## NEW PRODUCT ANNOUNCEMENT

**ADAPTER, REPLACEMENT, 4808, SET, U33/U38**

**ADAPTER, REPLACEMENT, 4808, SET, U22 - U28**

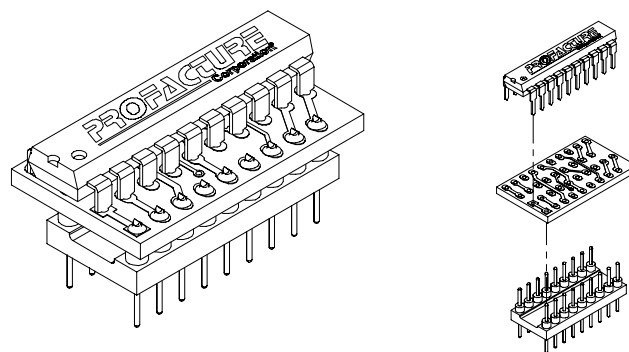
Compatible replacements are no longer available in the original 18 pin dip style package. The most common today is a 20 pin dip style package.

Adapter PCB's were designed and manufactured to accept these new package styles. Due to the space constraints on the Dacscan it was necessary to design two different types of adapters.

The adapter sets are supplied as a complete assembled set and also come with an 18 pin dip socket for ease of future replacements and Troubleshooting.
